Appendix E
LAX SPECIFIC PLAN AMENDMENT STUDY REPORT

Appendix E1
LAX SPECIFIC PLAN AMENDMENT STUDY REPORT

Airfield and Terminal Concept Development

**LAX Concept Development Report and Planning
Illustrations**

Advisory Committee Concept 1A
Existing Aircraft Parking Plan vs. Linear Terminal Configuration

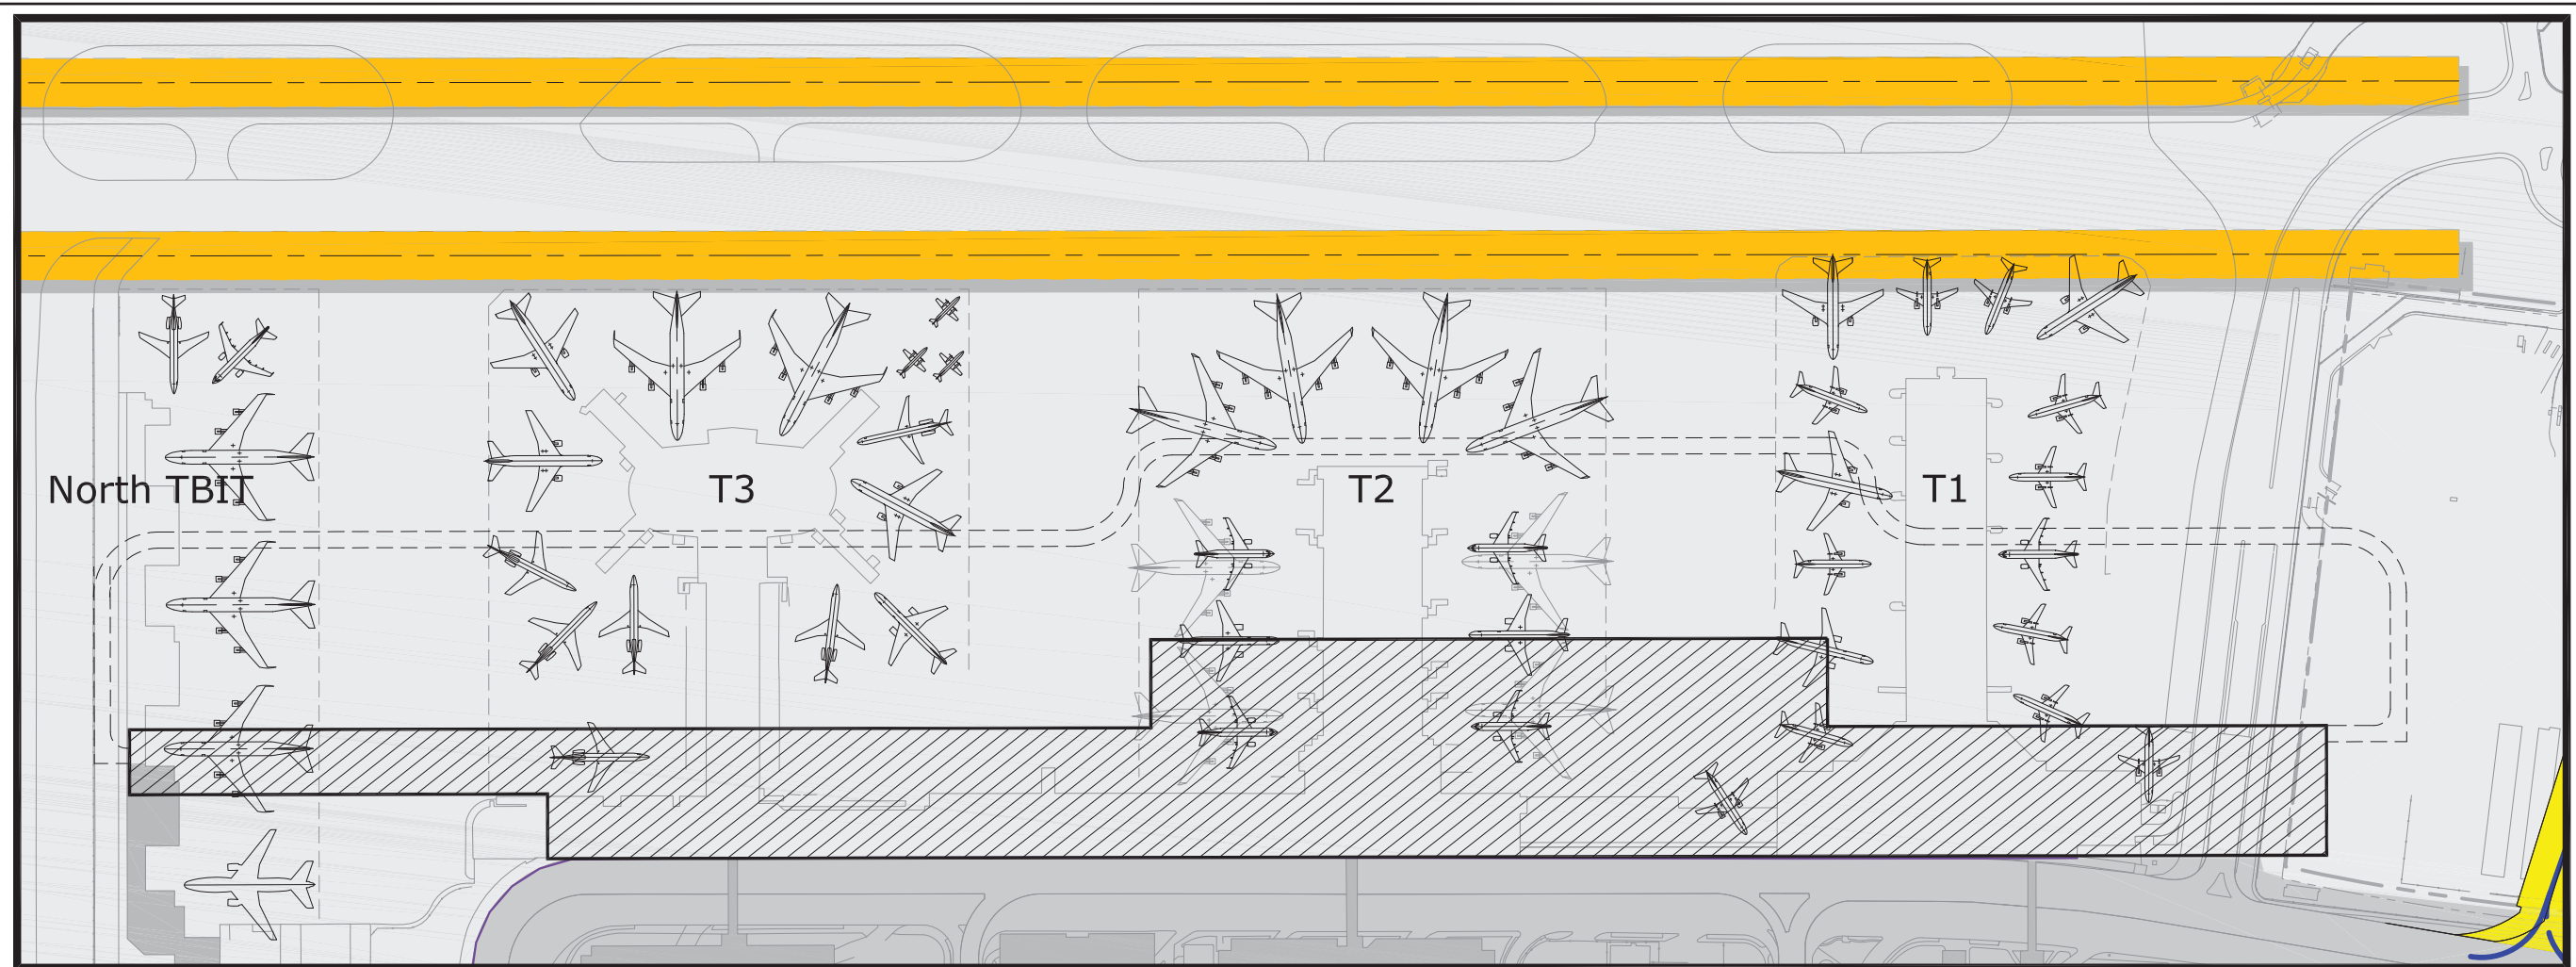
102	1/25/07	How many gates do you get when T1-3 get configured in a linear arrangement?	12-18 widebody gates.
103	1/25/07	How many gates do you get when T1-3 get configured in a pier arrangement?	20-25 widebody gates.

- Total Existing Gate Count
Terminal 1, 2 and 3 = **40-46 Gates**
- Existing Aircraft Linear Frontage
Terminal 1, 2 and 3 = **6,700 L.F**
- Number of Gates Lost Due To 100' Runway
Relocation = **25-30 Gates**

- Number of Gates at Linear
Terminal Configuration = **12 - 18 Wide Body Gates**
- Linear Terminal Configuration Aircraft Linear
Frontage = **3,400 LF Aircraft Frontage**
- 3 Level Terminal
Level 3 - Security, Holdroom Areas, Concessions.
Level 2 - Baggage Claim, Airline Offices.
Level 1 - FIS
- +- 337 Foot Wide Processor
+- 240 Foot Wide Concourse

Figure 1

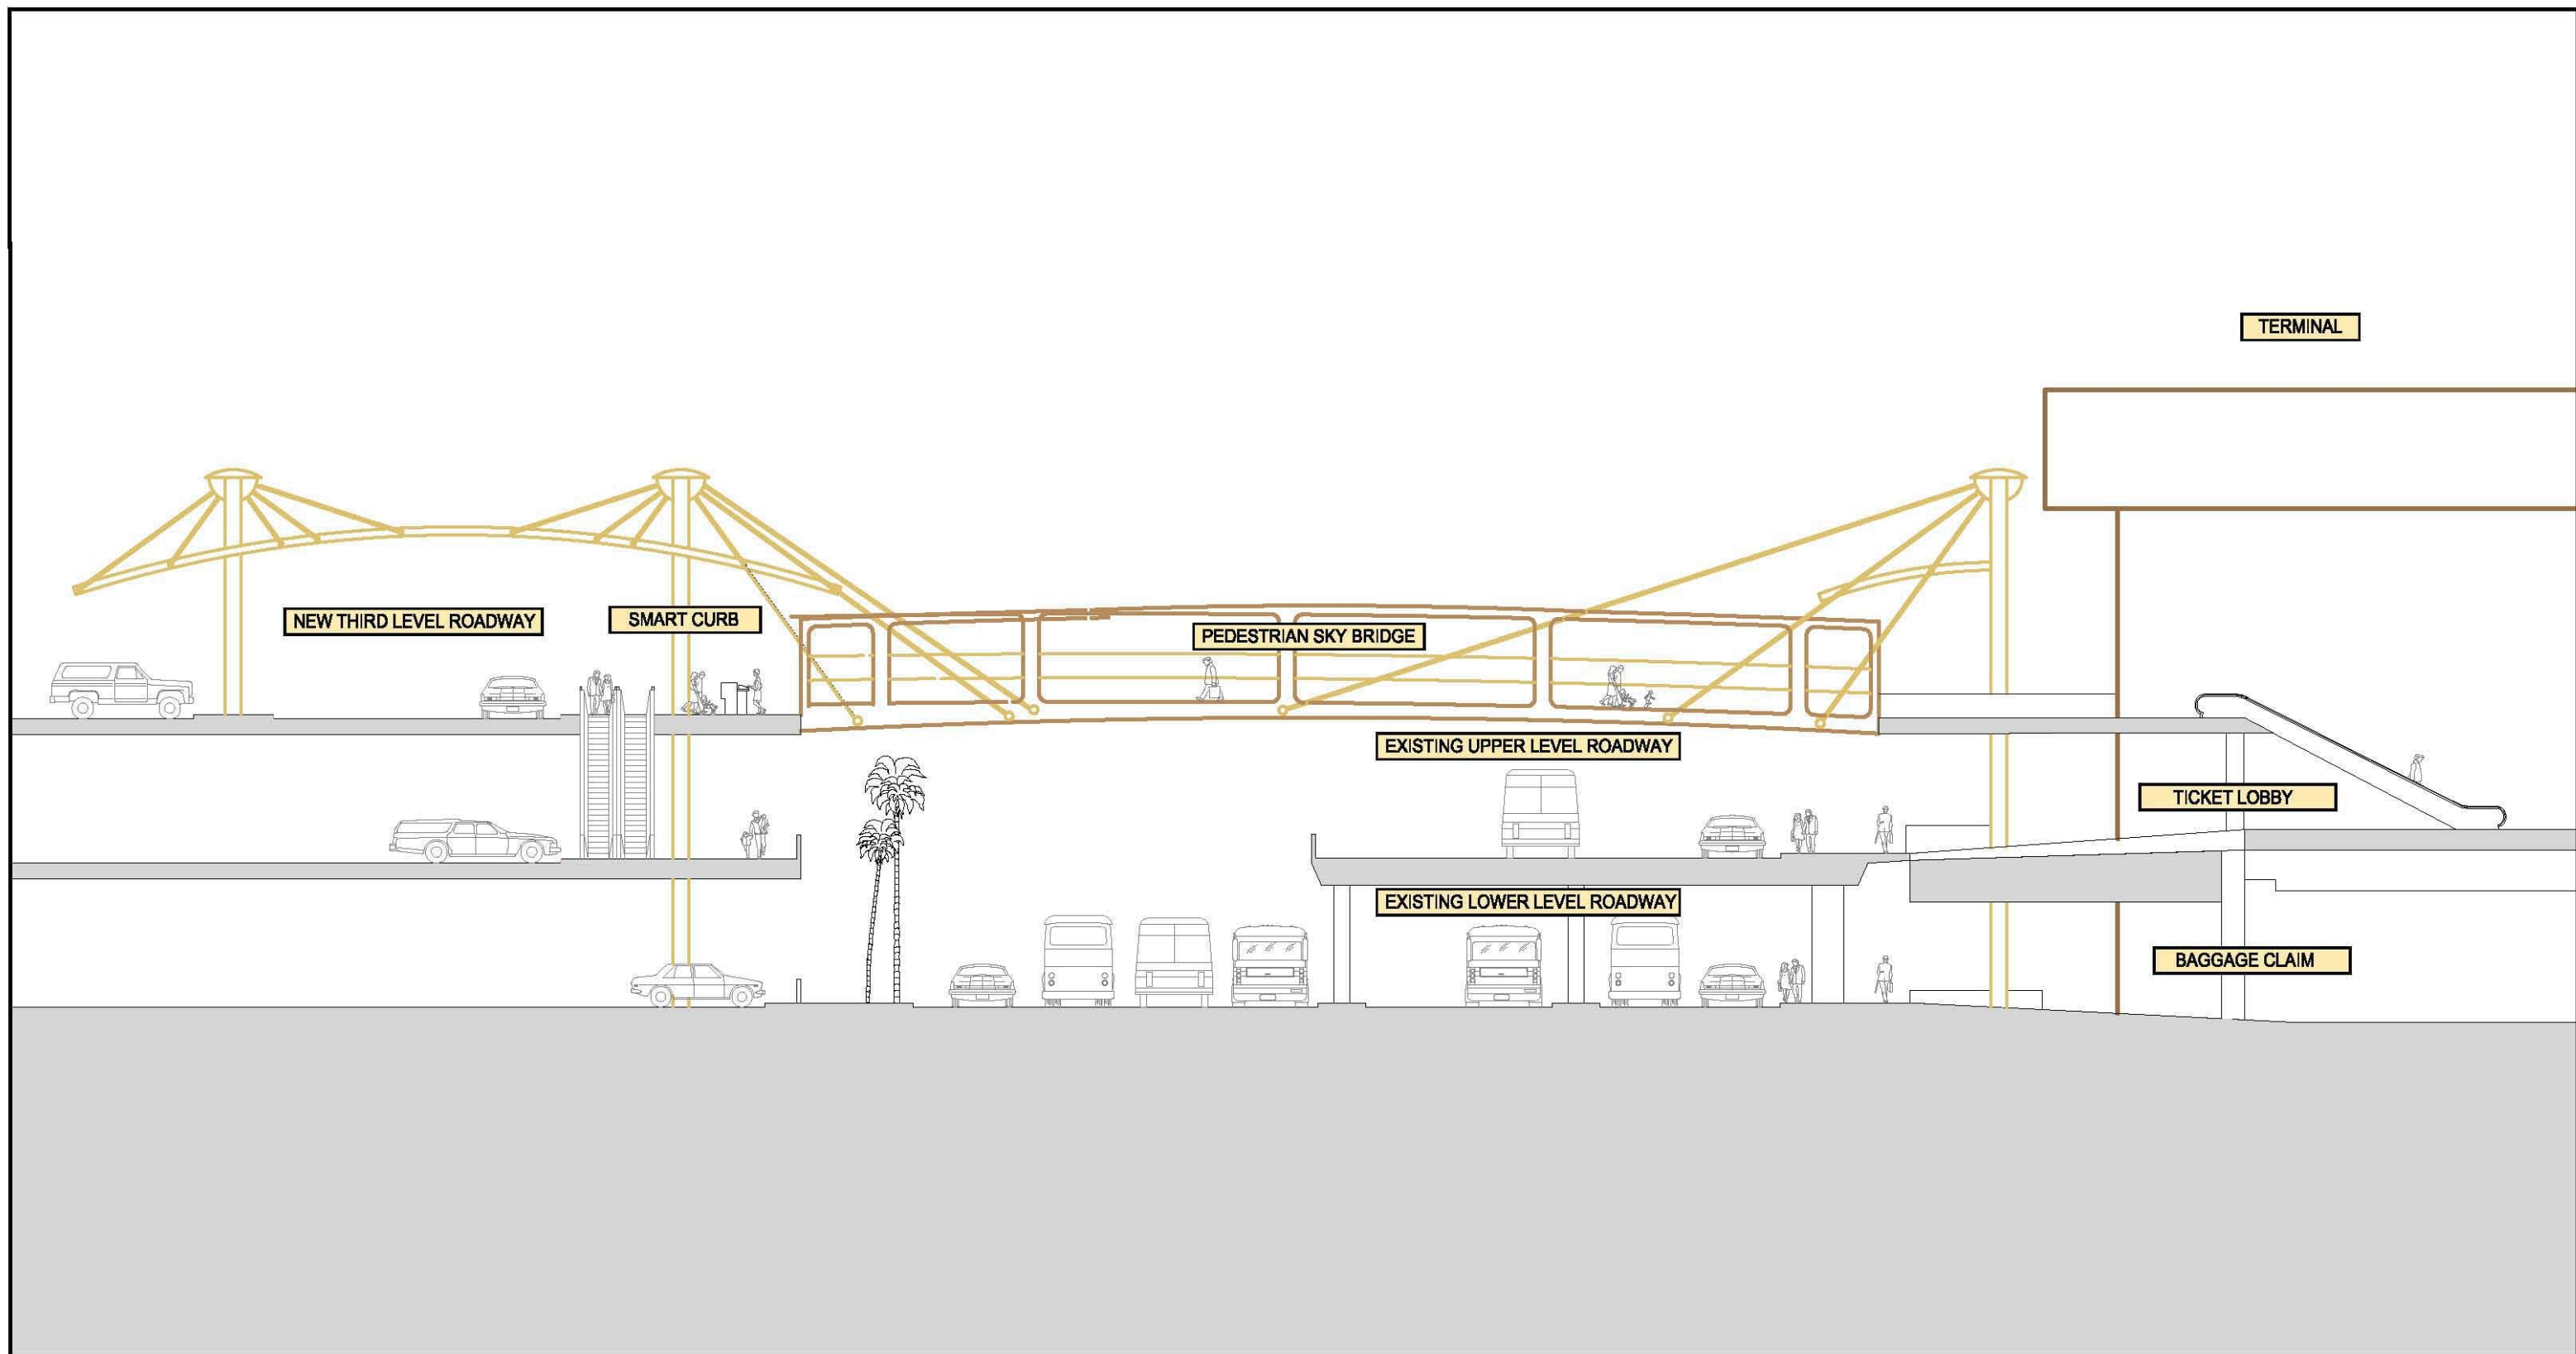
One request made by the Committee was for staff to develop a way to relieve traffic congestion and emissions within the exiting central terminal area envelope. A written description is accompanied by two figures which portays the concept.

The Advisory Committee had made the request for HNTB to look at alternatives which would ease congestion within the existing Central Terminal Area (CTA) roadway. The plan would be to rebuild all of the existing parking structures within the CTA, construct the new roadway that would take vehicles through the parking structures, and provide pedestrian bridges to enable passenger access to the terminals.

Figure 1 shows an alternative CTA roadway concept in plan (from above). This view has the parking structure located across from the Tom Bradley International Terminal (TBIT) labeled “New Processor”. This layout has been adopted in response to the need for additional passenger processing space for the Midfield Satellite. The new layout includes an additional roadway loop dedicated to serving the new processor.

All of the remaining parking structures would be rebuilt to provide 9,000 spaces which exist in the CTA today. New structures would be designed and laid out to maximize efficiency. The parking structures would be connected by way of the new 3rd level roadway that would “loop” around inside the confines of the existing CTA roadway.
